Process Sheet

Customer :	CU-DAR001 Dart Helicopters Services	Drawing Name :	A119 BUBBLE WINDOW
Job Number :	38842A		
Estimate Number :	12911		
P.O. Number :		Part Number :	D36242
This Issue :	28/04/2008	S.O. No. :	
Prsht Rev. :	NC	Drawing Number :	D3624 REV. D
First Issue :	/ /	Project Number :	N/A
Previous Run :	37199A	Drawing Revision :	REV. D
	Type :	Material :	
	THERMOFORMING	Due Date :	05/05/2008
Written By :		Qty:	2
Checked & Approved By :		Um:	Each
Comment :	Est. A Thermoform in house 6/27/2007 DL Est B. Revised due to corrupt operating Program. 7/23/2007 DL Est C. Dwg. Rev. change 7/30/2007 Est. D. Dwg. Rev. Updated 4/25/2008 verified by:DD

FIRST ARTICLE INSPECTION CHECKLIST

From: David Shepherd [dshepherd@dartaero.com]
Sent: April 30, 2008 6:19 PM
To: 'Chris Provencal'
Cc: 'Mike Petsche'
Subject: RE: NCR D3624-2 Bubble Window (A119)

DRAWING NO. REV. D
D3624 SHEET 1 OF 2
TITLE SCALE
BUBBLE WINDOW (A119) NTS

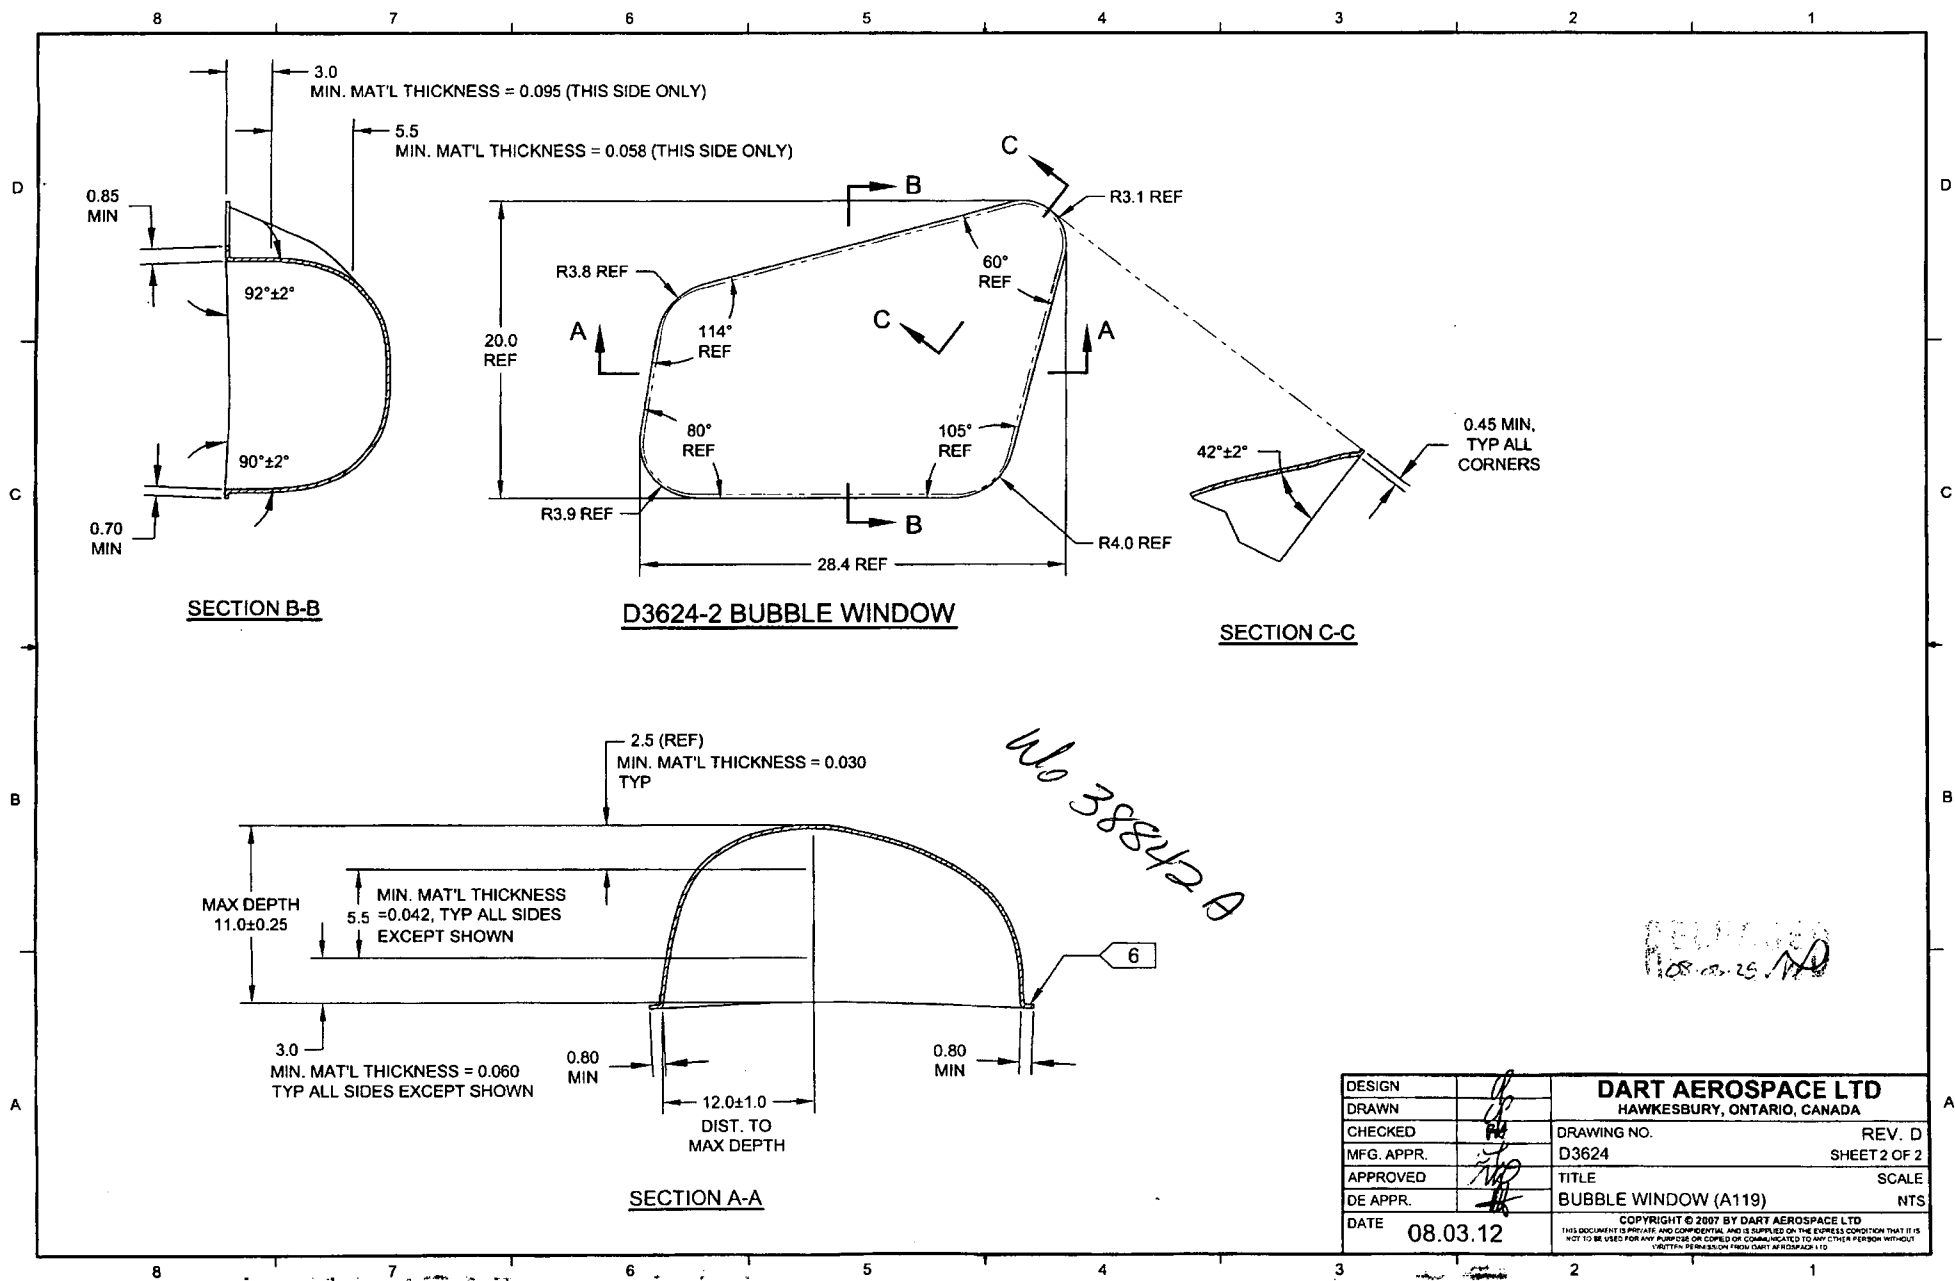
NCR: 38842A		WORK ORDER NON-CONFORMANCE (NCR)						
DATE	STEP	Description of NC Section A	Corrective Action Section B			Verification Section C	Approval Chief Eng	Approval QC Inspector
			Initial Chief Eng	Action Description Chief Eng	Sign & Date			
08.05.01	3	Qty(1) the depth is 1425" TRAILING EDGE ANGLE IS 93°.	 08.05.01 PV QSI 042	PART ACCEPTABLE REF DS EMAIL	N/A	 08.05.02	 08.05.01 PV QSI 042	 08.05.02

Drawing	Tolerance	Actual	Accept	Reject	Method of Inspection	Comments
Dimension		Dimension				
depth of bubble 11"	+/- 0.25"	10.25"		✓		Acceptable per Eng
leading edge at 3" high	0.095" min thick	0.098"	✓			Pro's position
leading edge at 8.5" high	0.058" min. thick	0.077"	✓			
trailing edge at 3" high	0.060" min thick	0.095"	✓			
trailing edge at 8.5" high	0.042" min thick	0.063"	✓			
top 2.5" of bubble	0.030" min thick	0.050"	✓			
leading edge angle 92°	+/- 0.2°	94°	✓			
trailing edge angle 90°	+/- 0.2°	93°	✓			
width leading edge flange	0.85" min	.90	✓			
width training edge flange	0.70" min.	.792	✓

Qty(1) D3624-2, the depth is 10.25" (should be 11.0"+/-0.25"). The trailing edge angle is 93 deg, instead of 90+/-2 deg. All the thicknesses are OK.

I think its OK, the depth is about what we get for the R44. I talked with Bill, he's OK with the depth if we are. This is not one of the ones shipped out this week.

Acceptable deviation.
